## Agenda Item #: 5

### SUB-002523-2023 & MOD-002522-2023

DAA-McVay Subdivision

APPLICATION NUMBER	5	DATE	June 15, 2023
APPLICANT	DAA-McVay Subdivision		
REQUEST	Subdivision, PUD Modification

## DETAIL SITE PLAN

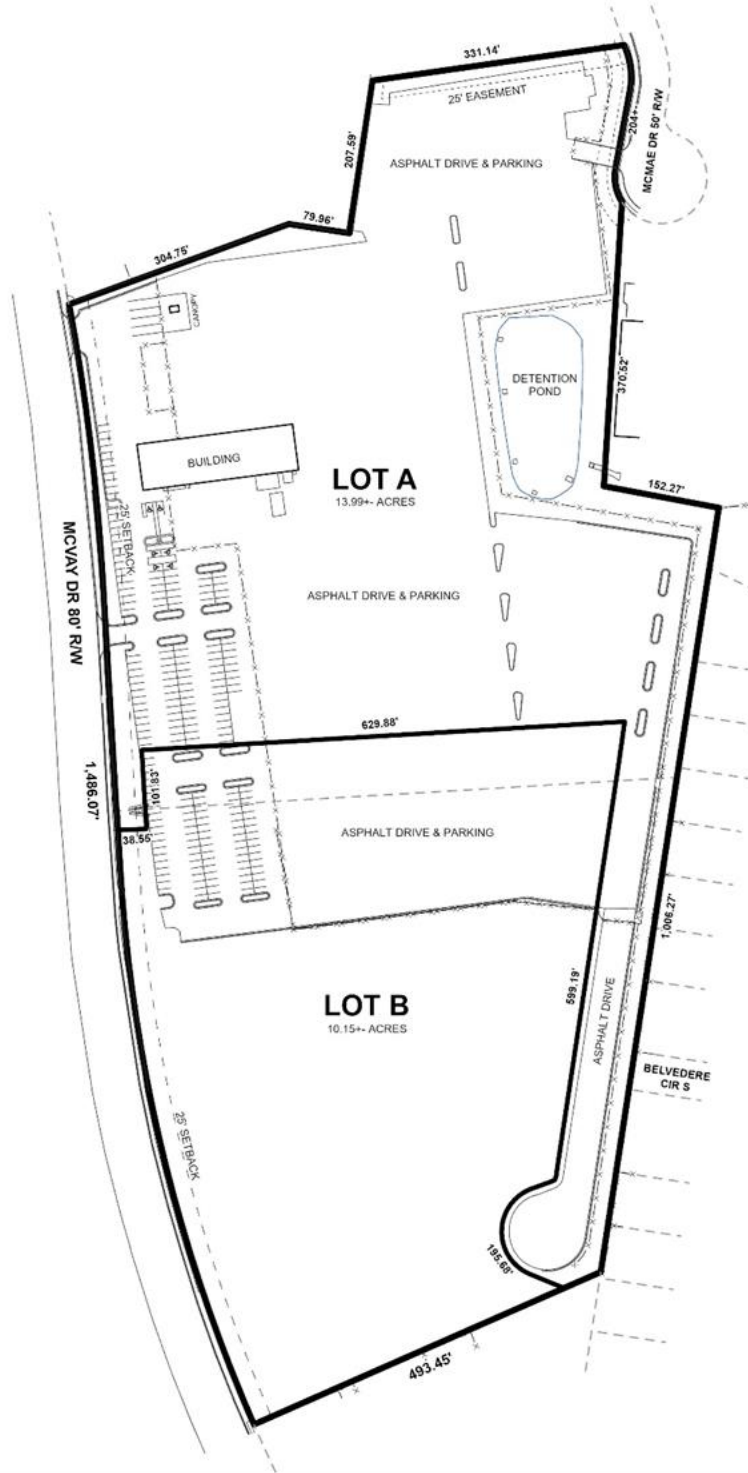
The preliminary plat shows a 25-foot minimum building setback line along McVay Drive North, and this should be retained on the Final Plat, if approved. The recorded 25-foot minimum building setback line along McMaie Drive is illustrated, but not labeled as such. Therefore, the plat should be revised to label the 25-foot minimum building setback line along McMaie Drive, if approved.

The preliminary plat indicates a recorded 25-foot drainage and utility easement along a portion of the Northern boundary of the site. Also illustrated, but not identified, is a recorded 10-foot slope easement along McMaie Drive. Therefore, the plat should be revised to label this easement. A note should be placed on the Final Plat

It should be noted that the proposed location of the common property line through existing parking and vehicle inventory areas will result in substandard parking circulation aisles. As such, the site plan should be revised to assure that all impacted parking and circulation areas are revised to comply with UDC requirements.

3. Retention of the 25-foot minimum building setback line along McVay Drive North;
4. Revision of the plat to label the 25-foot minimum building setback line along McMae Drive;

5. Revision of the plat to label the 10-foot slope easement along McMae Drive;
6. Placement of a note on the Final Plat stating that no structure may be placed or constructed within any easement without the permission of the easement holder;

# MODIFICATION SITE PLAN

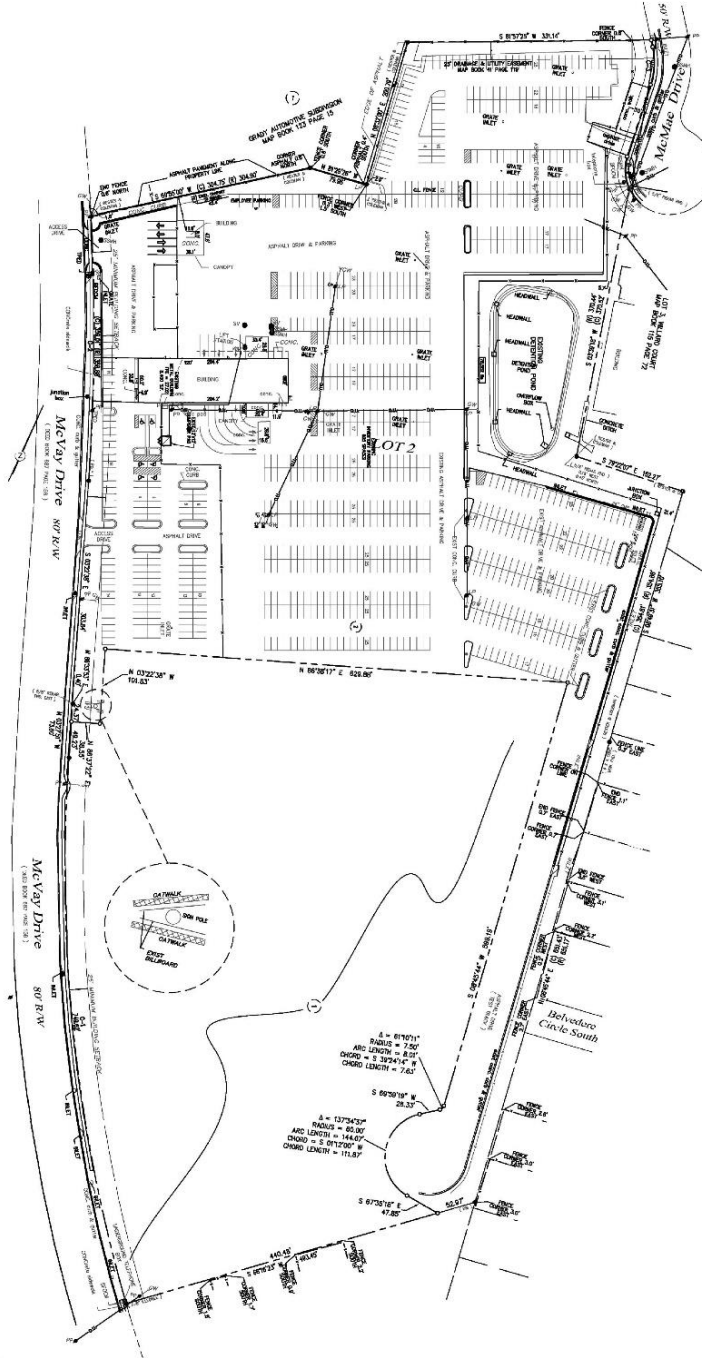
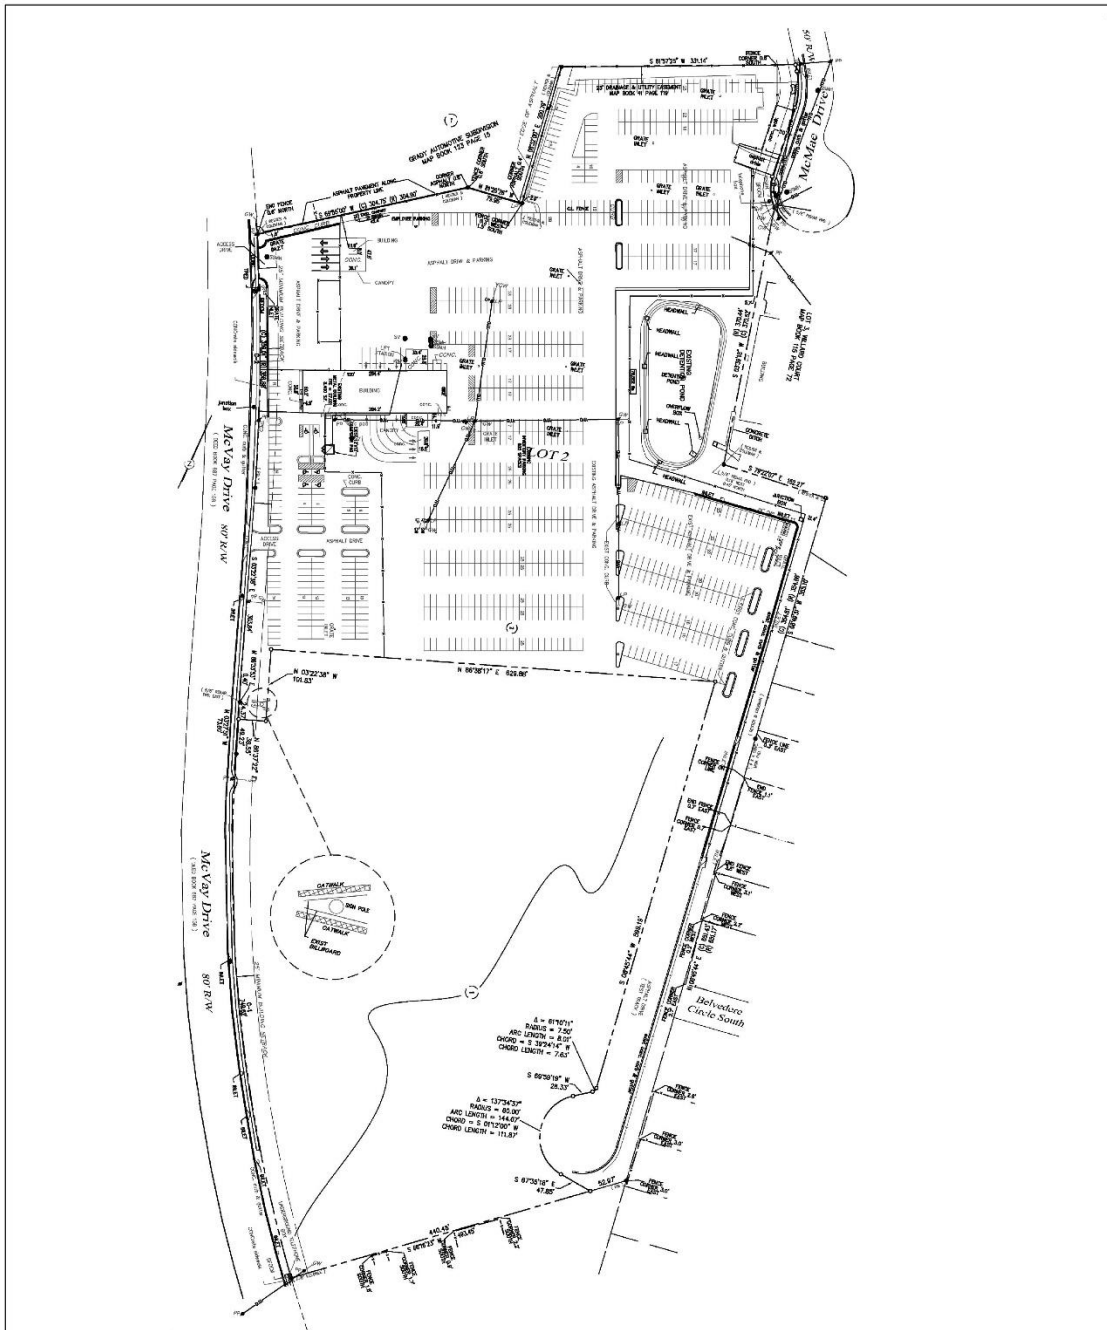
The site plan should also be revised to label each lot with its size in both square feet and acres to correspond with the associated subdivision, or a table should be furnished on the site plan providing the same information. The right-of-way widths of McVay Drive North and McMae Drive should be retained on the site plan. The 25-foot minimum building setback line should be retained as shown along McVay Drive North. As the 25-foot minimum building setback line is not labeled along McMae Drive, the site plan should be revised to do so. The site plan should also be revised to label the 10-foot slope easement along McMae Drive.

As the site plan indicates easements within the site, a note should be placed on a revised site plan stating that no structure may be placed or constructed within any easement without the permission of the easement holder. Proposed Lot 1 is developed and proposed Lot 2 is vacant; however, as the purpose of the current application is to create Lot 2 and remove it from the current PUD, only Lot 1 will be required to modify the previously approved PUD in the future.

1. Revision of the site plan to ensure that parking and access aisles on Lot 1 impacted by the property line relocation remain compliant with UDC requirements;

2. Revision of the site plan to label each lot with its size in both square feet and acres, or the furnishing of a table on the site plan providing the same information;

3. Retention of the right-of-way widths of McVay Drive North and McMaie Drive as depicted on the site plan;
4. Retention of the 25-foot minimum building setback line along McVay Drive North;

5. Revision of the site plan to label the 25-foot minimum building setback line along McMaie Drive;
6. Revision of the site plan to label the 10-foot slope easement along McMaie Drive;

7. Placement of a note on the site plan stating that no structure may be placed or constructed within any easement without the permission of the easement holder;

8. Placement of a note on the site plan stating that future proposed development on Lot 1 will require a Modified PUD;
9. Compliance with all Engineering comments noted in this staff report;
